Product Change Notification (PCN)

PCN #: 10C-2019

DATE: 10/31/2019

5.1 Top Level Part Number C hanges (packaged kits)

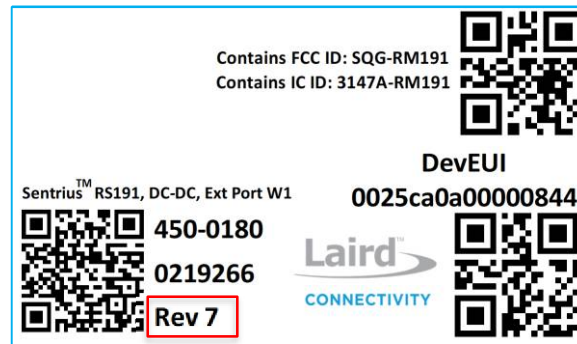
- Revision change available as revision number printed on kit content label for all kits (Label located on the bottom left corner of the base kit label). Specific kit part number and revision printed on the label within red square area.

Note: Label located on the bottom right corner of the kit base label contains the same label info as printed on the sensor contained within the specific kit ([On Sensor Changes](#) section).
